**AUGUST 3, 2015**

**BOARD OF COUNTY COMMISSIONERS  
ORANGE COUNTY, FLORIDA  
ADDENDUM NO. 2 – Y15-7009-PH  
ORANGE COUNTY EASTERN WATER RECLAMATION FACILITY  
PHASE I/II AUTOMATIC BACKWASH FILTER REHABILITATION  
BID OPENING DATE: AUGUST 6, 2015**

**C-7**

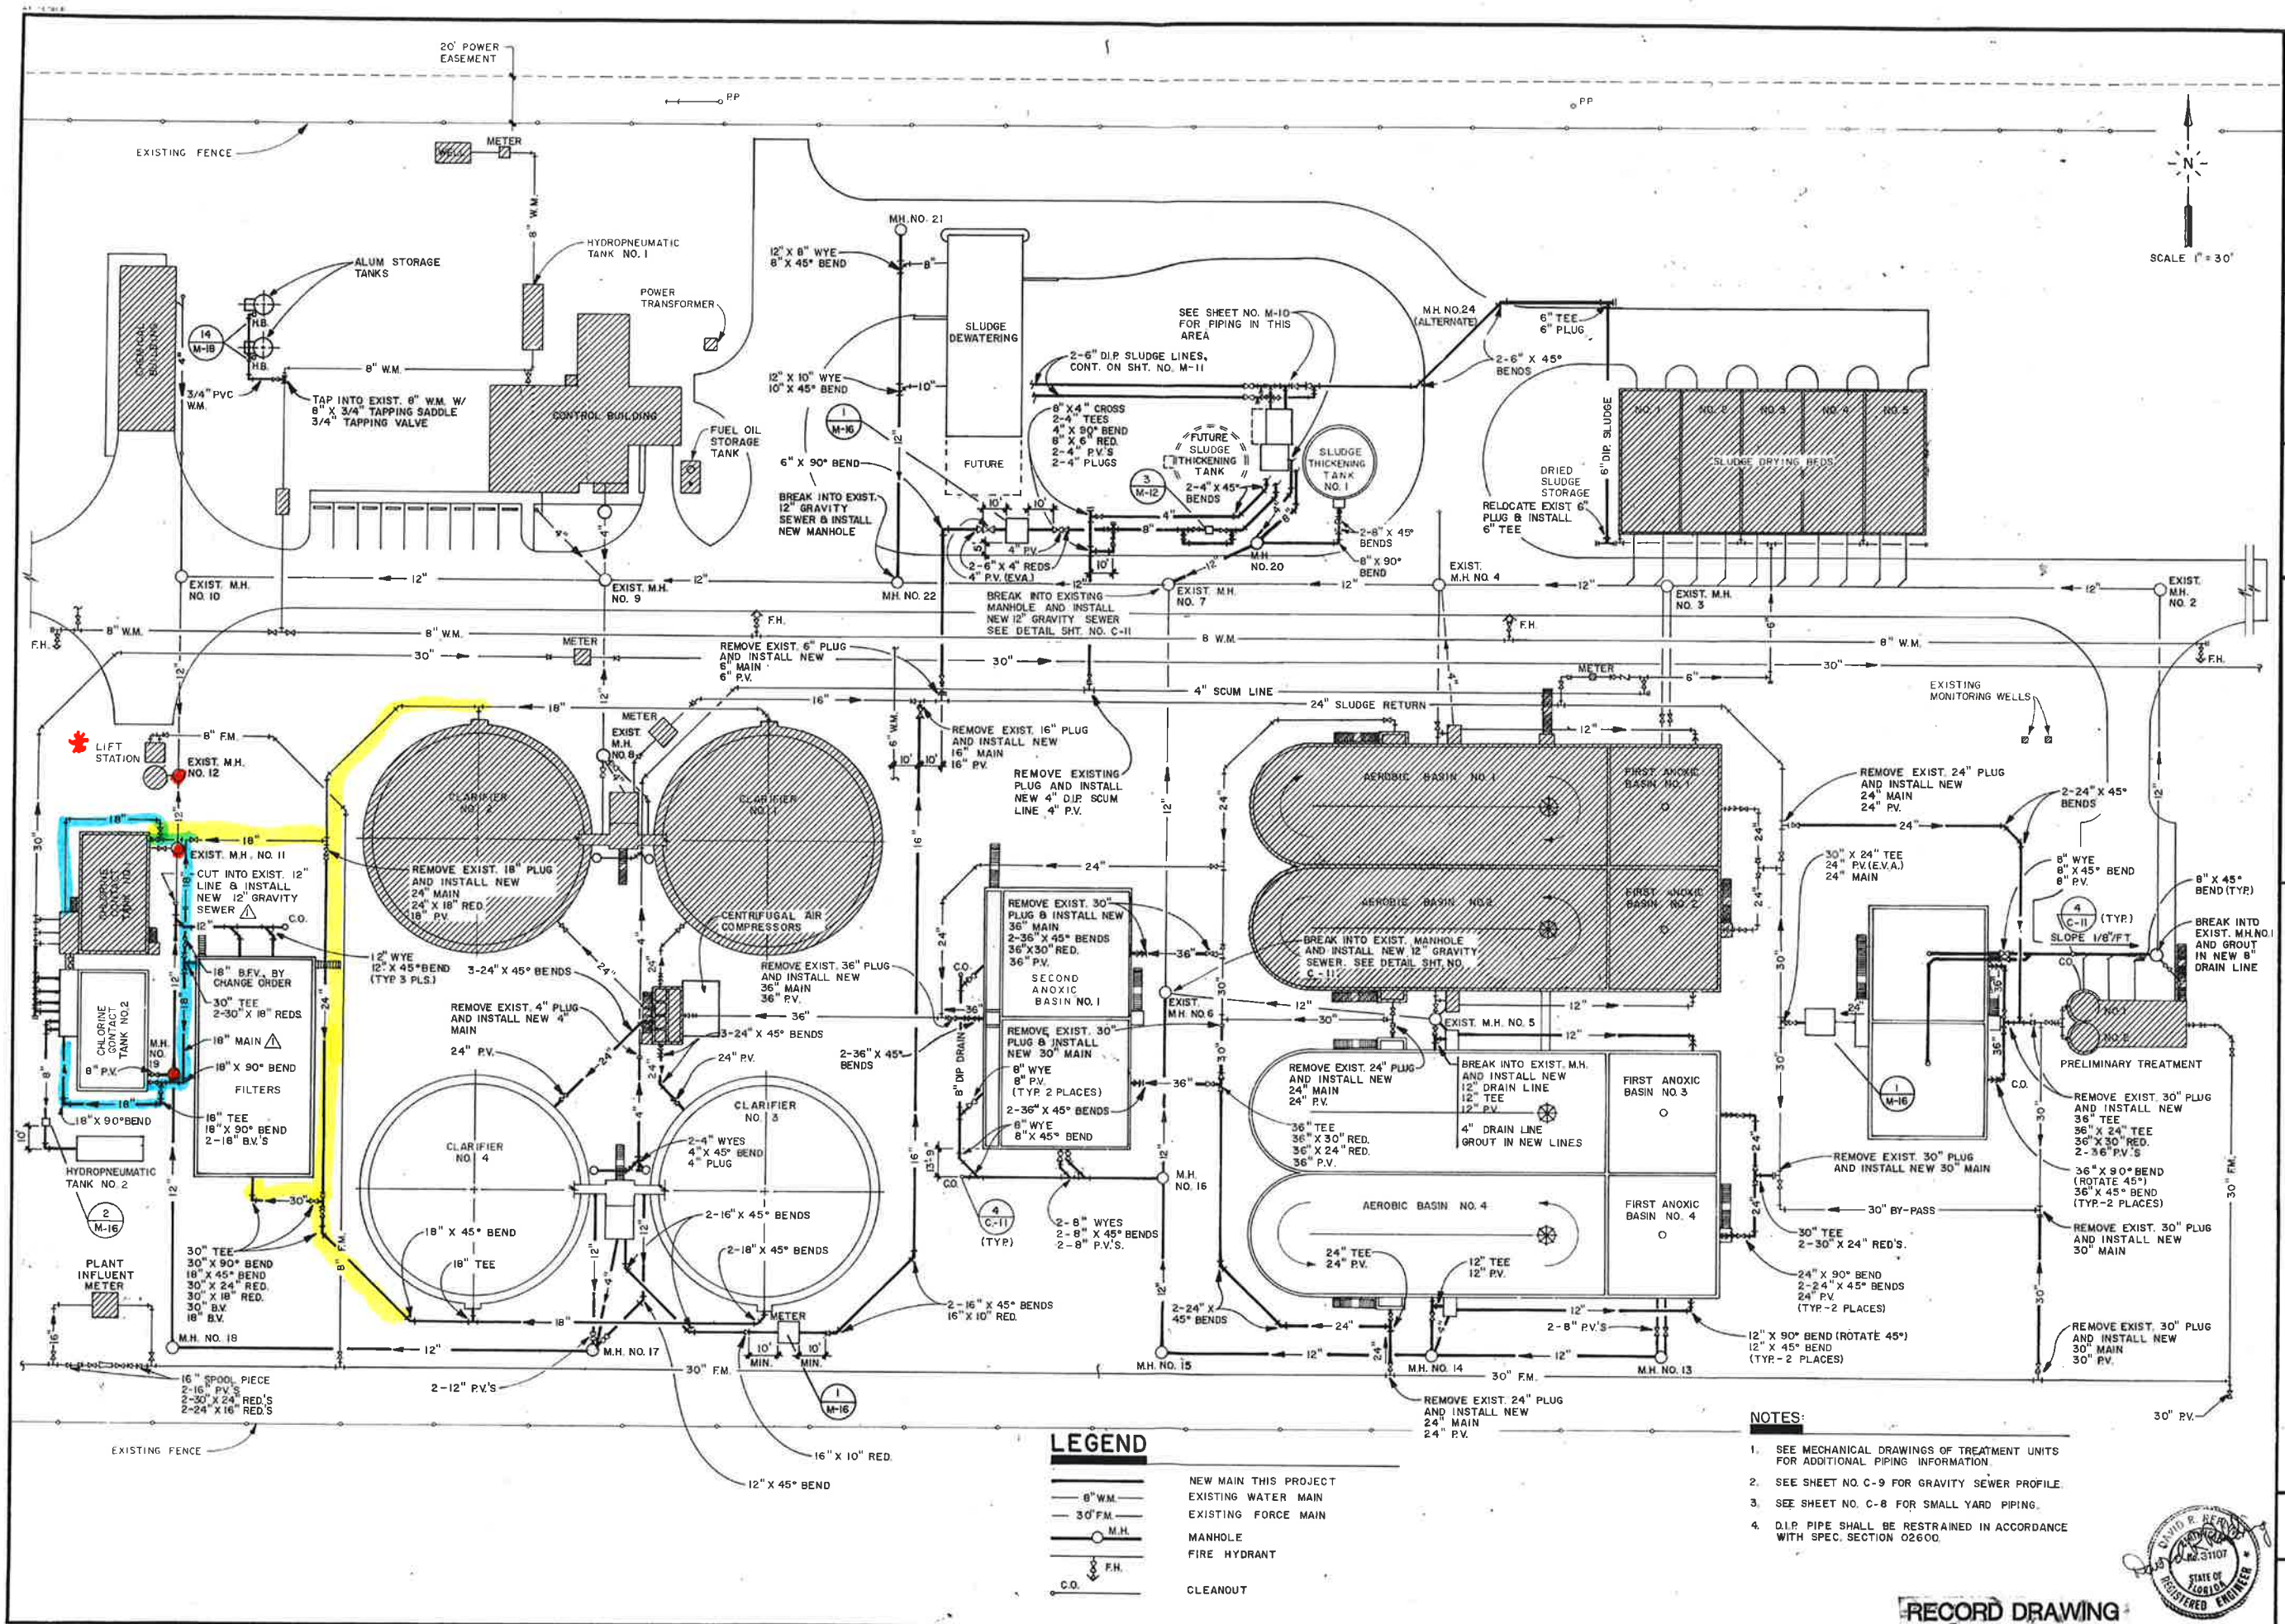
**Question 5:** Can the waste discharge from the Aquadisk be discharged into one of the waste channels at the existing filter? If not what is the approximate distance to the nearest available discharge location for discharging the waste back to a return line?

**Answer:** The Record Drawings for this area show three available tank drainage manholes and one lift station. See attached sheet C-7. Manholes are shown as a red dot.
